ADA Curb Ramp New Construction Inspection Form (Parallel)

Nw 314th ave

24952.54

Nw. Commercial st.

PARALLEL RAMP (PL)

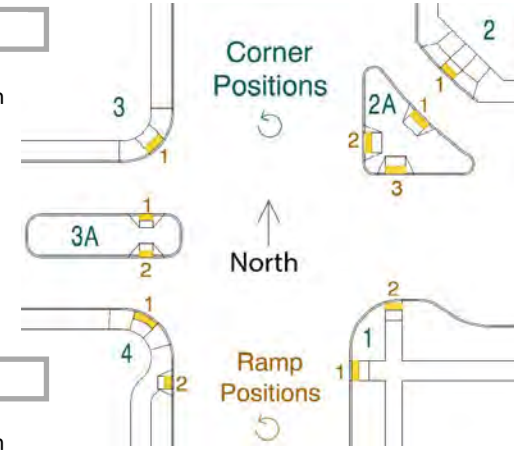
15.2 $\leq 2.0\%$ ☐ $> 2.0\%$ ☒

6.9 $\leq 2.0\%$ ☐ $> 2.0\%$ ☒

1.0 $\leq 1/4"$ ☐ $> 1/4"$ ☒

☐ 9 $\leq 8.3\%$ ☐ $> 8.3\%$ ☒

5.1 $\leq |5.0\%|$ ☐ $> |5.0\%|$ ☒

3.5 $\geq 4.0'$ ☐ $< 4.0'$ ☒

No dome, no RR2, no RR3
